Hi-Fi Products
Service Bulletin

Model: TC-K700ES

No. 7

Subject: Improvement of Wow and Flutter

【System Control Board】

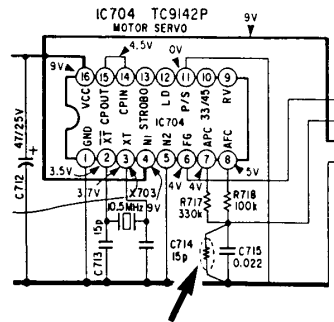
Wow and flutter is generated just after play is initiated.

Mount a 820K Ω resistor here

Add an 820K Ω resistor (P/N 1-215-491-00) in parallel with C715 on the system control board.
